## State Water Resources Control Board

# RESPONSE TO PUBLIC COMMENTS FOR DRAFT STORM WATER RESOURCE PLAN GUIDELINES

Figure 1. Example project "type."

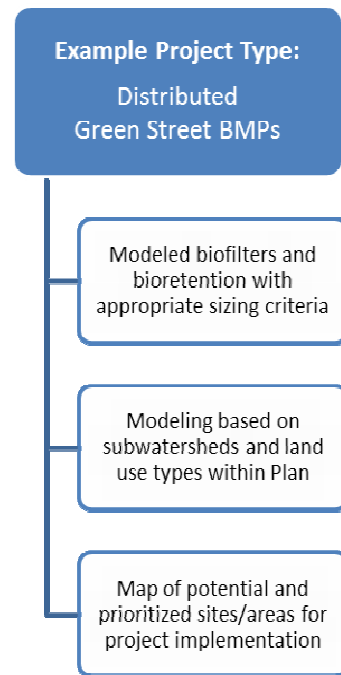
The commenters state that it is not appropriate to set a specific numeric design storm capture performance threshold for a project because: (1) it may be infeasible for water capture projects that deliver many other benefits to achieve an 85<sup>th</sup> percentile, 24-hour storm capture volume, or (2) an 85<sup>th</sup> percentile, 24-hour storm capture volume is infeasible for many watersheds throughout the state.

One commenter (*California Water Partnership, CWP 20*) supports the 85<sup>th</sup> percentile, 24-hour storm threshold, and also suggests that capture of the 95<sup>th</sup> percentile storm should be encouraged in the Plan Guidelines.

Additionally, the definition of “project” has been clarified in the draft Guidelines; a “project” includes a collective of project activities and programs (such as distributed green streets across a subwatershed) that may collectively capture a storm event volume, rather than on an individual activity basis. The new definition for “project” states the following: *includes “project type” and consists of an entire set or group of opportunities, programs, actions or activities (including structural and non-structural implementation of management measures and practices).*

The Plan Guidelines were revised to clarify that projects included in the Plan may be individual projects or “project types” that will result in the Plan’s proposed watershed outcomes, as demonstrated through a quantitative metric-based analysis in the Plan. Figure 1 was added to the draft Guidelines to further illustrate the newly expanded definition of “project”.
